NRC-03-016

February 27, 2003

KEWAUNEE NUCLEAR POWER PLANT
DOCKET 50-305
LICENSE No. DPR-43
NMC RESPONSES TO NRC REQUEST FOR ADDITIONAL INFORMATION CONCERNING
LICENSE AMENDMENT REQUEST 187 TO THE KEWAUNEE NUCLEAR POWER PLANT
TECHNICAL SPECIFICATIONS (TAC NO. MB5718)

KEWAUNEE NUCLEAR POWER PLANT
REQUEST FOR ADDITIONAL INFORMATION
REGARDING TECHNICAL SPECIFICATION CHANGES
FOR USE OF WESTINGHOUSE VANTAGE PLUS FUEL
(TAC NOS MB5718)

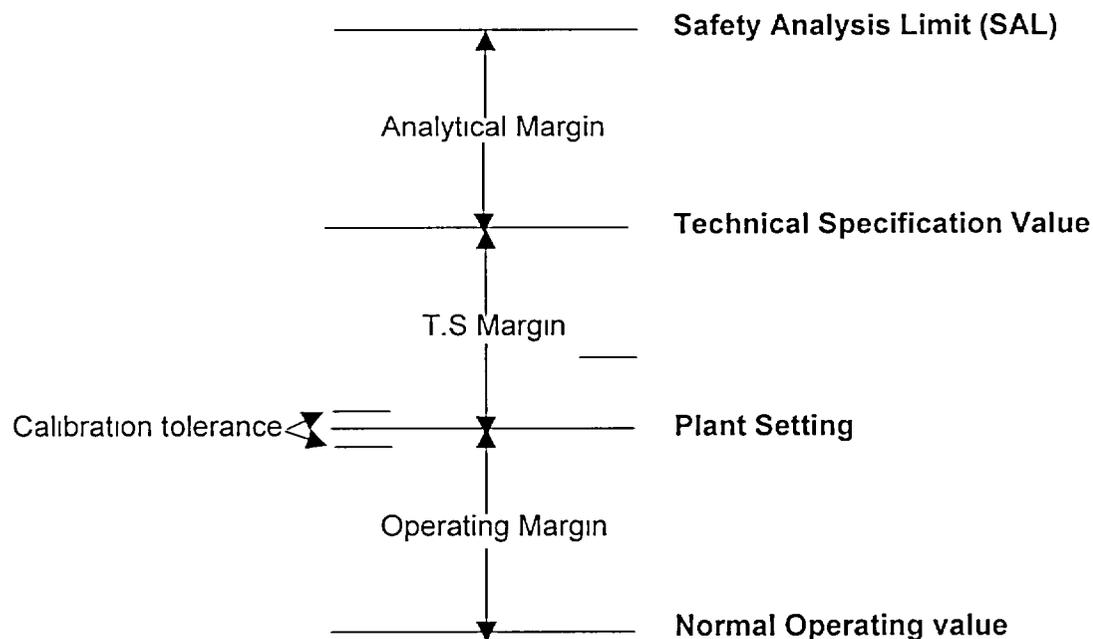
The conclusion that all reactor trip setpoints used in the new update power analyses are more restrictive than the current setpoints is meant to convey the following. Since all reactor trip plant setpoints (except the ΔT trips) retain the existing setpoint values and the normal operating values (e.g., power, T_{avg} , T_{out} , ΔT) have increased, the operating margin present in the updated plant has been effectively decreased. The decrease in operating margin implies that the setpoints are more restrictive for the updated plant than for the non-updated plant. Refer to the figure below for clarification.

The ΔT trip parameters have been revised as stated above, in some instances increasing and in some instances decreasing the operating, technical specification, and analytical margins. It cannot be simply stated that the revised ΔT setpoints represent more or less operating margining, only that the technical specification, analytical and safety margins are adequate, as demonstrated by the safety analyses.

Figure 58-1: Peak Cladding Temperature Comparison

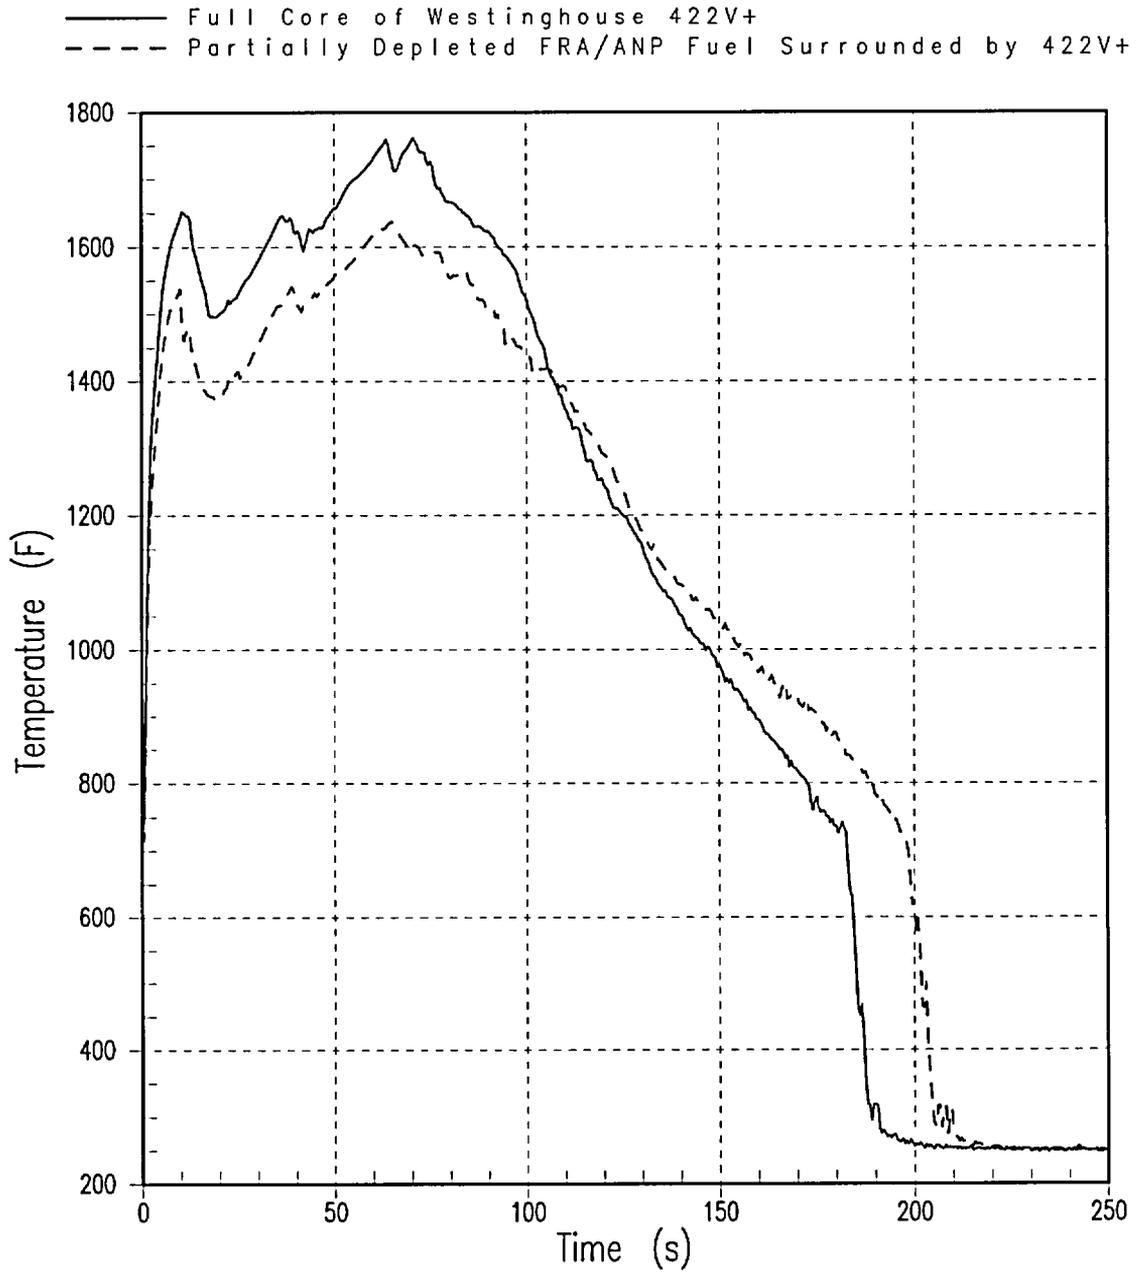
Figure 58-1 shows the PCT transients for a full core of 422V+ fuel compared to a transition core with partially depleted Framatome ANP fuel surrounded by 422V+. This calculation was performed using the reference transient conditions as defined by the Westinghouse methodology in WCAP-14449-P-A. Figures 58-2 and 58-3 compare the RCS pressure transients for those two runs, for the entire transient, and for the reflood portion, respectively. Figure 58-4 compares the hot assembly collapsed liquid level. It can be seen that the core configuration has little effect on the RCS pressure or hot assembly collapsed liquid level.

The reflood PCTs from Figure 58-1 are 1763°F for the full core 422V+ calculation, and 1638°F for the calculation with partially depleted Framatome ANP fuel surrounded by 422V+. This difference of 125°F was calculated assuming that the Framatome ANP fuel would operate at the same peaking factors as the Westinghouse fuel ($F_Q = 2.50$ and $F_{\Delta H} = 1.80$). However, the Framatome ANP fuel will continue to have Tech Spec peaking factor limits of $F_Q = 2.35$ and $F_{\Delta H} = 1.70$. Based on power distribution studies performed for the Westinghouse fuel, it is estimated that the lower peaking factors would reduce PCT for the Framatome ANP fuel by roughly 130°F.
